Product Change Notification (PCN) T-1407

P4S Header

Notification change of plating specification.

Narrow Pitch Connector P4S Header

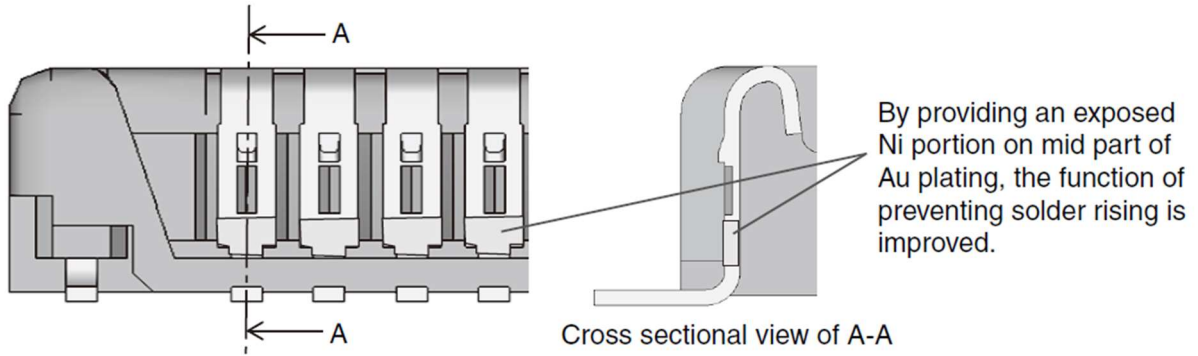
- Solder rising is prevented in P4S header due to simultaneous forming. By changing to an Ni barrier construction the prevention of solder rising is improved even further.
- Part number, price and specification remain unchanged.

What is Ni barrier construction?

- * Depending on the product type, the lower part of the V notch may assume the Ni color. This will not affect contact reliability.
- * In previous products, the socket already has the Ni barrier.
